Subject: Oconee Nuclear Station  
Docket Nos. 50-269, -270, -287  
Response to Request for Additional Information on  
the Oconee Emergency Power System

REQUEST FOR ADDITIONAL INFORMATION  
OCONEE EMERGENCY ELECTRICAL POWER  
DISTRIBUTION SYSTEM

3LP-17  
ES Test #5  
b phase of current

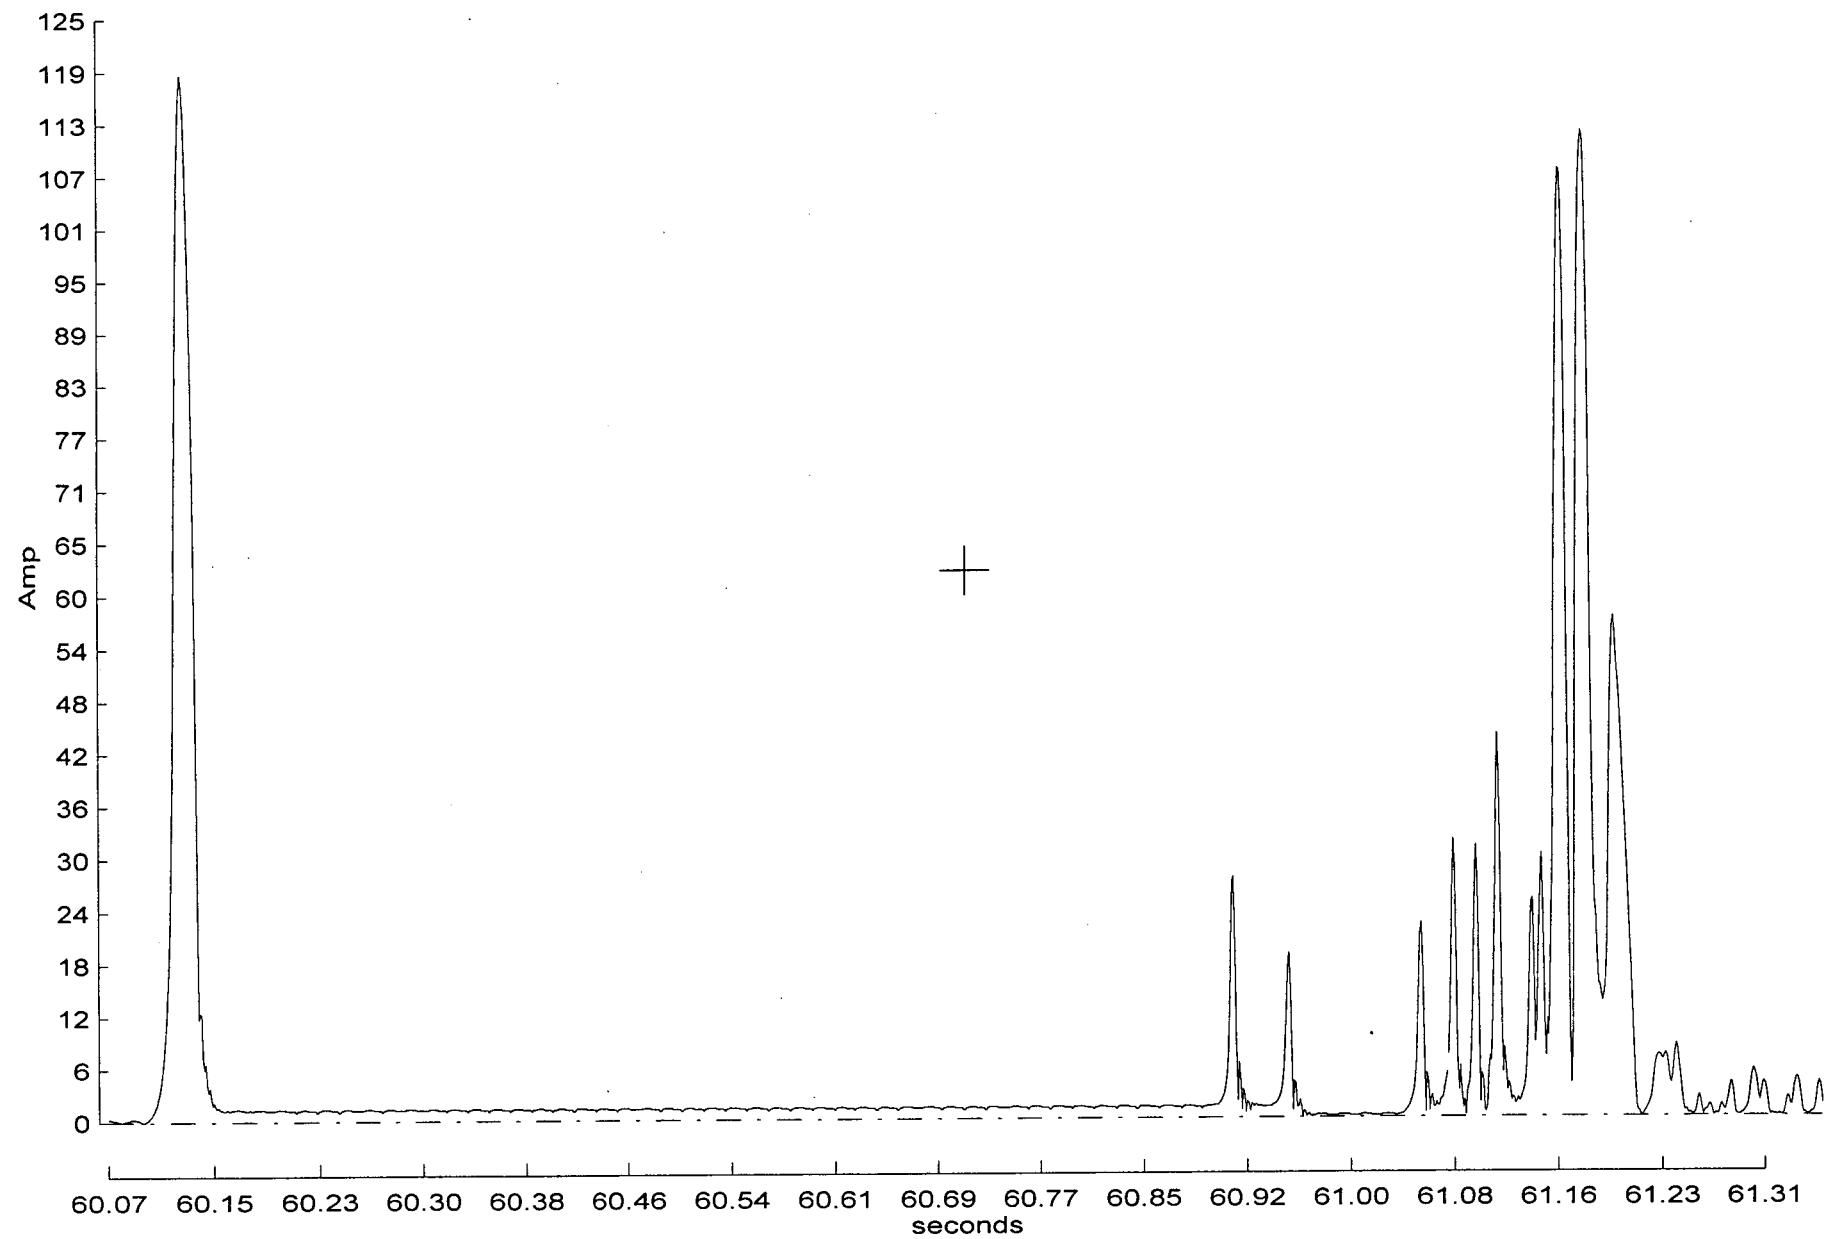
7. Section 5.2.4 of the report states that MOV 3LP-17, which is a gate valve, briefly stalled while starting following contactor pickup during Tests 4, 5, and 6. The stall times were 1.0, 1.0, and 0.4 seconds, respectively, for the three tests. The report indicates that the valve recovered in each case and completed its stroke to its proper ES position; and following inrush, valve stroke was normal and normal hammer-blow and unwedging was observed. We note that in all the LOCA tests where the MOVs are actuated, this particular valve's motor contactor picks up at a voltage value that is quite often one of the largest values seen on the group of valves that are monitored. On that basis, not considering any other variables, it would be expected that this valve would be the least likely to stall.

- d. Please provide plots of the valve motor's thermal capability and overload protection, overlaid on the starting inrush current figures shown for this valve during the tests.

monitored phases was analyzed for inclusion in the report since all valve stroke events could be identified regardless of which phase was analyzed. A more detailed review of the data for all three monitored phases indicates that the primary reason 3LP-17 appeared to stall was that the 'c' phase starter contact chattered while the 'a' and 'b' phase contacts maintained a stable energized state. Therefore, the 'a' and 'b' phases (one of which was included in the report) indicated stall conditions until the 'c' phase contact maintained a stable energized state. Once all three phases were energized, 3LP-17 stroked as expected. In retrospect, 3LP-17 did not actually stall as originally thought. Attachment 6 contains the plots of the current data for 3LP-17 which indicate the chattering of the 'c' phase contact.

Copies of the requested plots are contained in Attachments 2 through 6.
